Cory Decarbonisation Project

Responses to Deadline 4 submissions and ExQ2 on behalf of Landsul Limited and Munster Joinery (U.K.) Limited

Figure 3-1: 11 kV Switchgear.

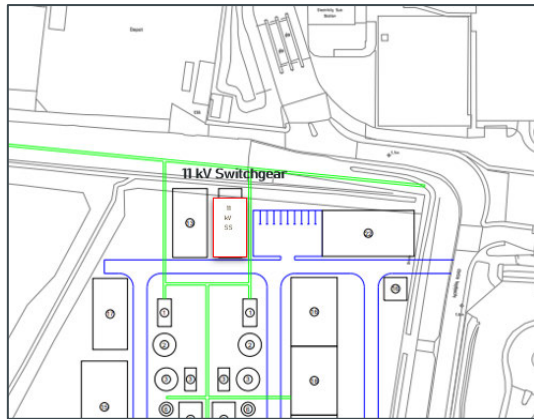
- The area highlighted in Figure 3-1, measuring approximately 10m x 30m, is designed to accommodate all the 11kV switchgear panels for the alternative 11kV layout, which should be sufficient for the system. Additionally, there will be extra space to house two small distribution transformers, if necessary. The remaining transformers will be positioned near the load as required. In the previous report, the mentioned area of 10m x 7m was the tentative size proposed for the 11kV switchgear room intended to accommodate a $2 \times 50\%$ 22MW load without the need for a GCB. However, the total area shown in Figure 3-1 is approximately 10 m x 30 m.

Although the 11kV switchgear room size will be increased if 2x 100% 44MW redundant system is considered, as the 11kV switchgear rating will be increased resulting in larger space requirement, the suggested area should be enough for the 11kV switchgear room. The 11kV connection details are discussed in the next section.

Figure 4-1: SLD Showing a Direct Connection to the AIB on the Transformer Side of the GCB – R1.

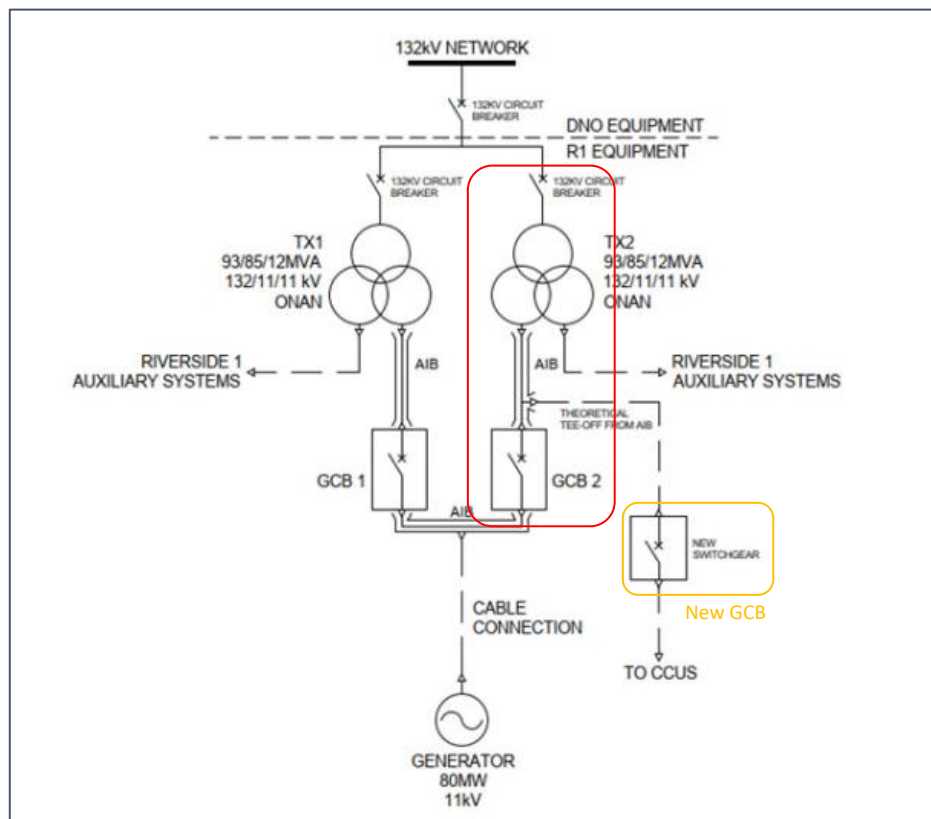
The proposed connection option for 11kV at Riverside 1 is by taking a tee-off connection from the AIB (Air Insulated Bus-Duct, as shown in the figure above) connection between the GCB and the transformer. A new switchgear assembly would be required to provide protection and isolation for the CCF cable (Cory cable, as specified in the WSP report) and denoted by "TO CCUS" in the figure above.

Regarding the potential requirement to shutdown Riverside 1, the GCB and 132kV Circuit Breaker (CB) can be isolated (as it is a 2 × 100% system, i.e. there are two fully rated 132kV transformers, so the network will remain energised), and following the isolation of the CBs, the AIB modification work can be carried out. This means that the power station could continue to operate whilst the AIB modifications are carried out. The red marking shown in Figure 4-1 shows the isolated zone.

Figure 4-2: SLD Showing a Tee-off Connection from the IPB – R2.

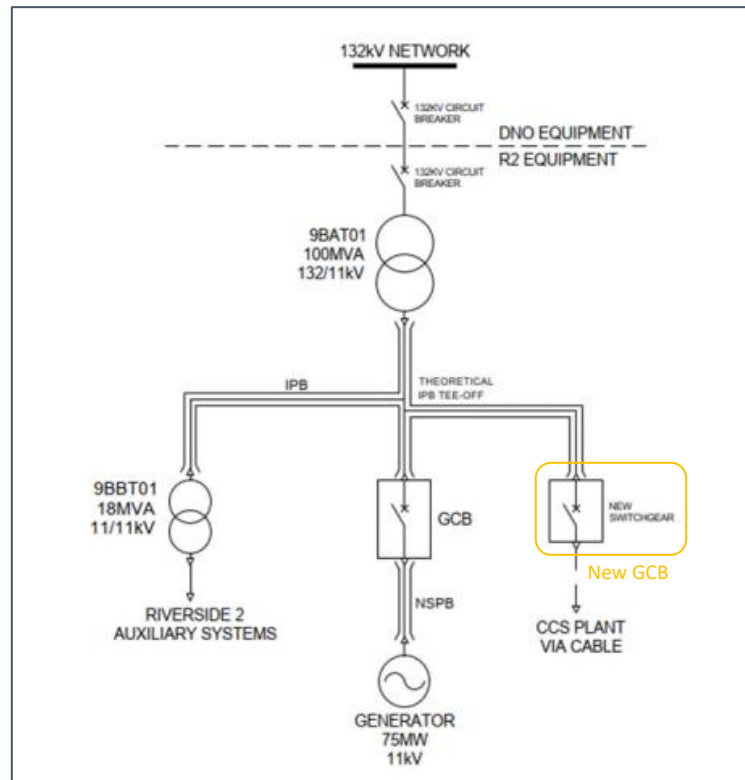
After observing the details of the connection, the best possible connection option for 11kV at Riverside 2 is by taking a tee-off connection from IPB (Isolated Phase Busducts) between the GCB and the transformer. A new switchgear assembly would be required to provide protection and isolation for the CCF cable.

Since Riverside 2 is not commissioned yet, there is the possibility of making the tee-off connection and installing the GCB before the energisation of the system, which will help in resolving the space constraint concerns for the IPB connection. In addition, the shutdown of the whole system can be managed if this modification work is carried out before energisation.

For GCB installation, a small room / containerised switchroom can be installed near the transformer area, or an existing building should be able to be modified.

Figure 1- CCP area vs MWth Input (BEIS Benchmark)

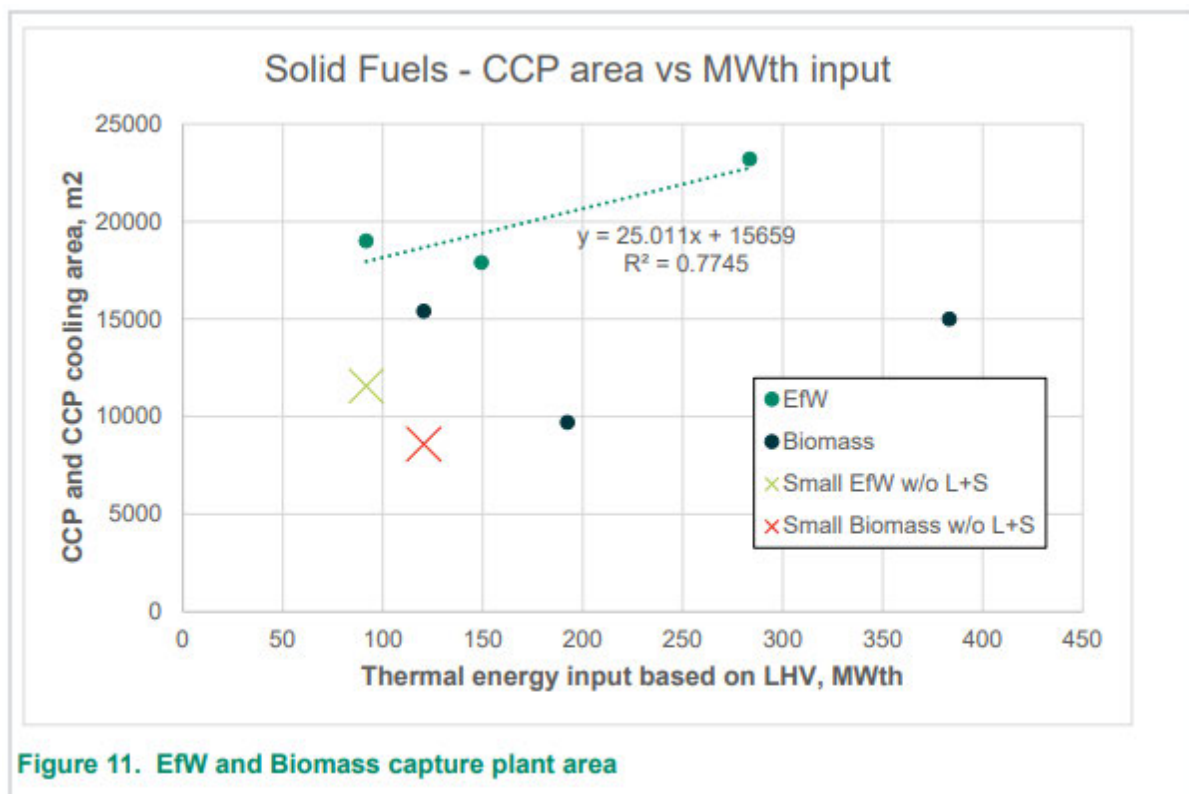
I estimate that the thermal input for the combined Riverside 1 and 2 facilities will be in the order of 500 MWth. Therefore, based on the BEIS guidance, the required footprint can be calculated to be:

Figure 2- Footprint vs Carbon Capture Capacity

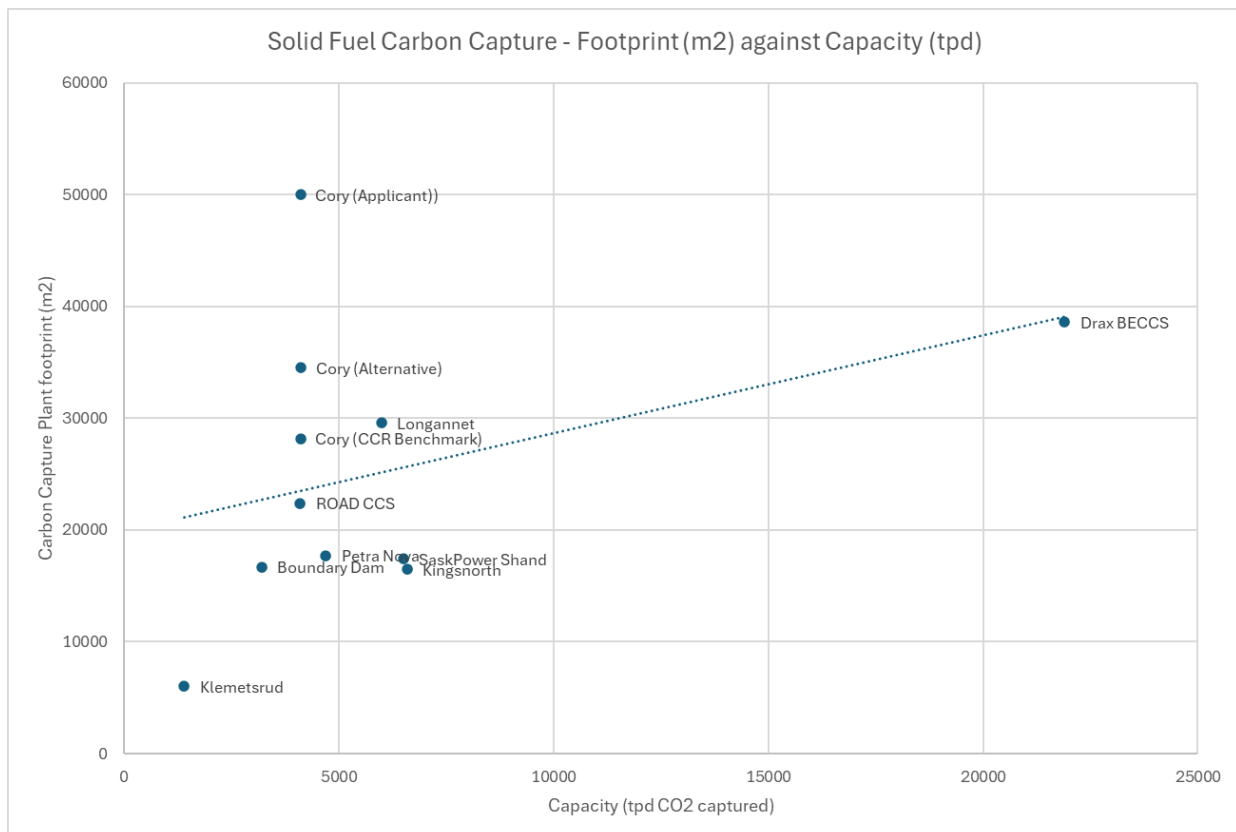
It can be seen that all of the Cory estimates sit above the average line.

It is unsurprising that the Carbon Capture Readiness (CCR) benchmark is higher than the average for the other projects given the AECOM statement that *“For larger plant, it is expected that the calculated trendline would provide a reasonable conservative basis in the absence of site-specific data which may allow a reduction.”*
